# UNITED STATES PATENT AND TRADEMARK OFFICE

<b>Office Action Summary</b>	<b>Application No.</b> 10/580,370	<b>Applicant(s)</b> MALEK, PIERRE	
	<b>Examiner</b> RAFAEL ORTIZ	<b>Art Unit</b> 3728

## **DETAILED ACTION**

Fig. 1

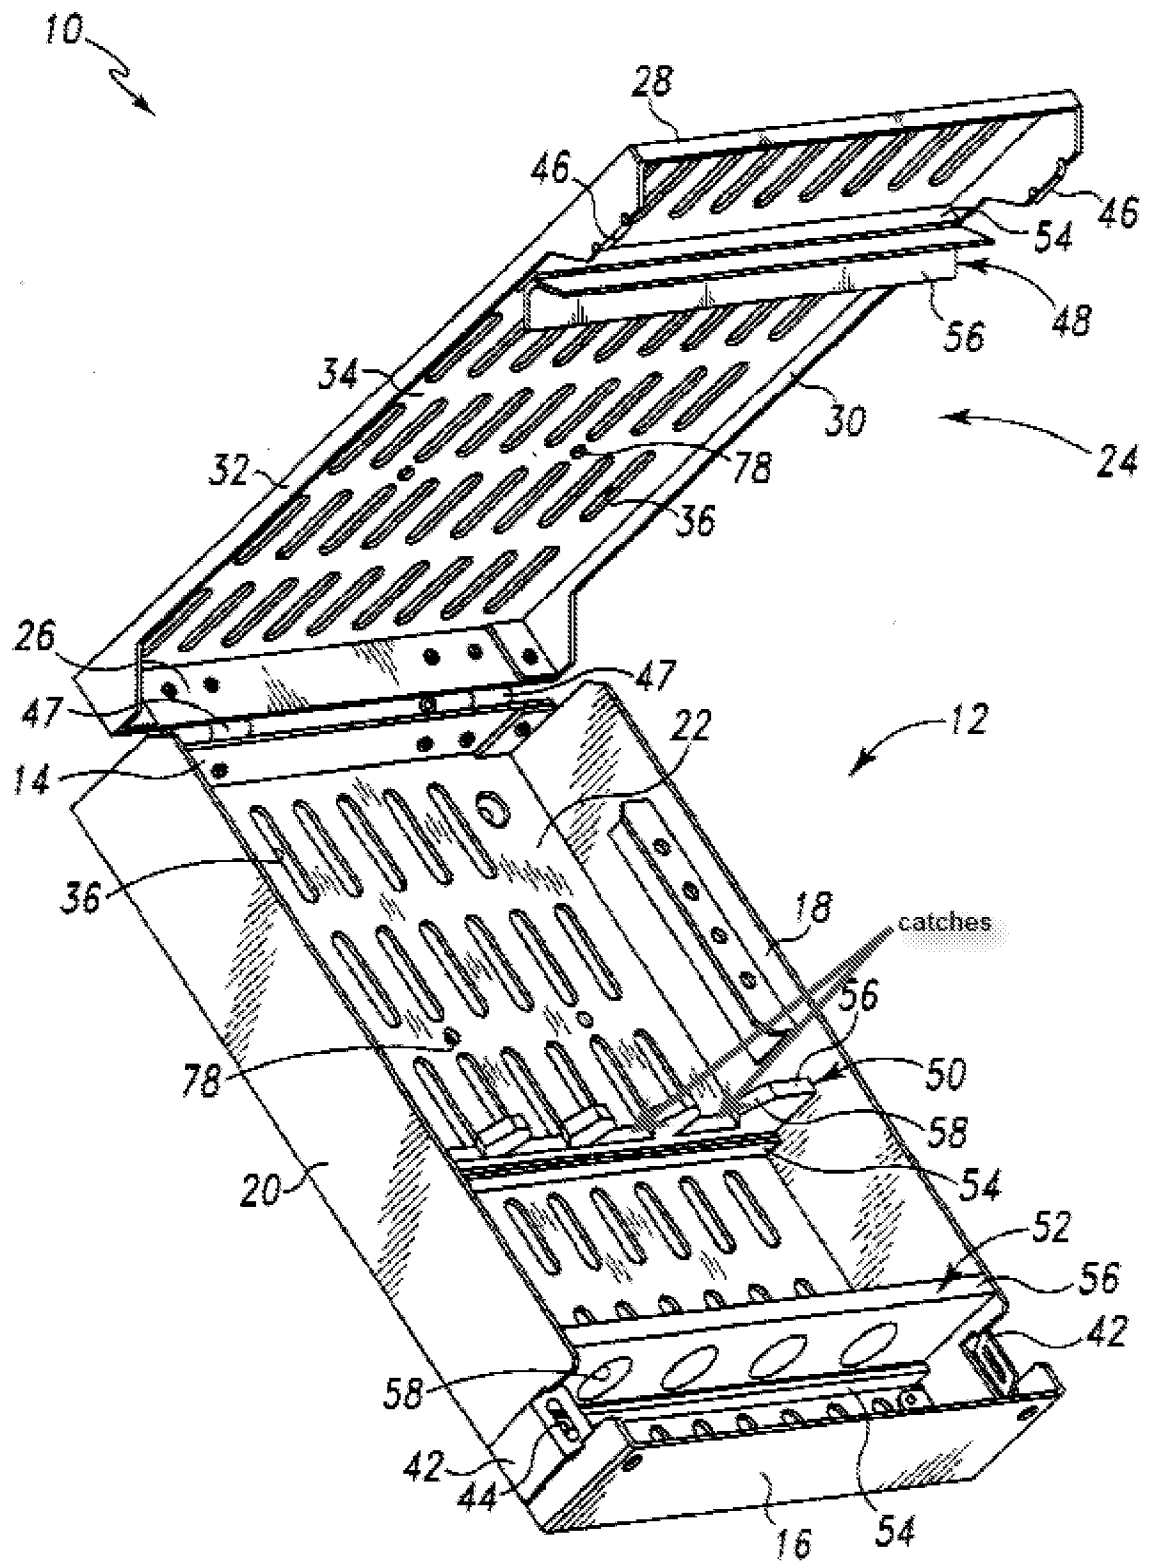
Spencer further discloses the lid (12) having two catches extending perpendicular to the lid in order to be in contact with a tool (see figure above).
